### 3.5 Missile Protection

STP DEP 3.5-1 (Table 3.5-1 and ~~deletion of~~ Figure 3.5-2)

**Figure 3.5-2 Low-Trajectory Turbine Missile Ejection Zone**

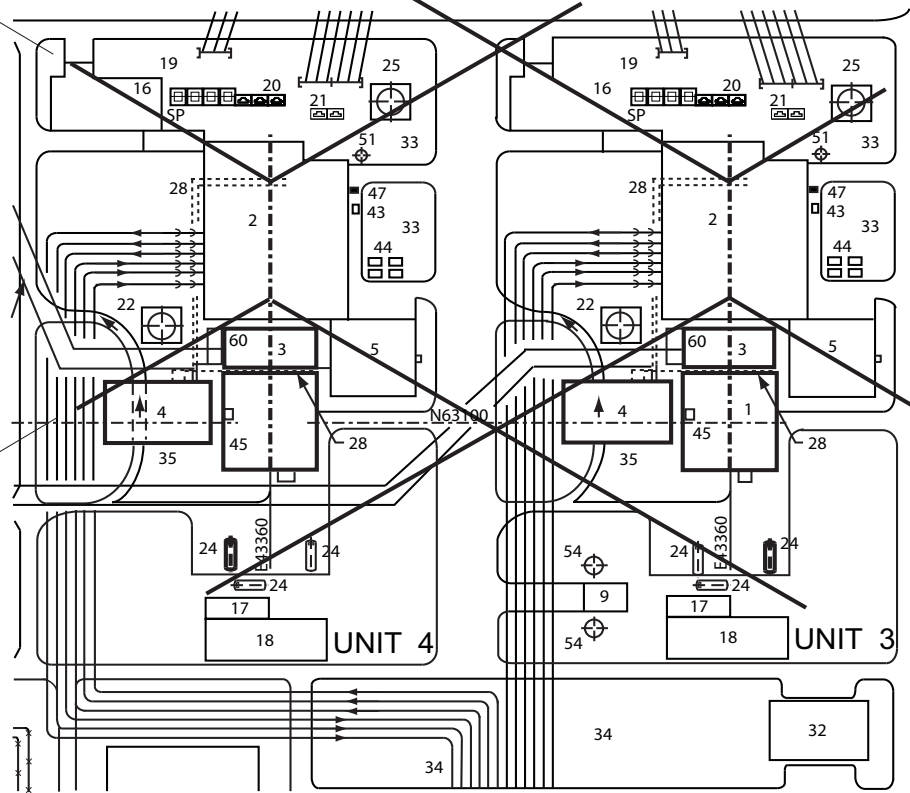
~~Acceptance Criteria 1 of SRP Section 3.5.1.3 considers a plant with a favorable turbine generator placement and orientation and adhering to the guidelines of Regulatory Guide 1.115 adequately protected against turbine missile hazards. Further, this criterion specifies that exclusions of safety-related structures, systems or components from low trajectory turbine missile strike zones constitutes adequate protection against low trajectory turbine missiles. The turbine generator placement and orientation of the ABWR Standard Plant meets the guidelines of Regulatory Guide 1.115 as illustrated in Figure 3.5-2.~~

The STP 3 & 4 turbine generator placement and orientation in relation to essential systems of the STP 3 & 4 Reactor Buildings, Control Buildings, Ultimate Heat Sink (UHS), and to STP 1 & 2 adjoining unit are ~~shown~~ illustrated on Figure ~~1.2-1~~ 3.5-2. Per Regulatory Guide 1.115, the STP 3 & 4 turbine generator placement and orientation is considered unfavorable. Per Acceptance Criteria 1 of Standard Review Plan Section 3.5.1.3 for unfavorable turbine generators, a value of  $10^{-2}$  per year per plant was chosen as a conservative value for the product of strike probability ( $P_2$ ) and damage probability ( $P_3$ ). The criteria for unfavorable turbine generator orientation given in Standard Review Plan Table 3.5.1.3-1 and provided in Table 3.5-1 was assumed for the missile generation probability ( $P_1$ ). The resulting probability of unacceptable damage from a main steam turbine missile ( $P_4$ ), which is  $P_1 \times P_2 \times P_3$ , is less than  $10^{-7}$  per year per plant.

Therefore STP 3 & 4 main steam turbine generator placement and orientation meets the acceptance criteria of Standard Review Plan 3.5.1.3 and the guidelines of Regulatory Guide 1.115.
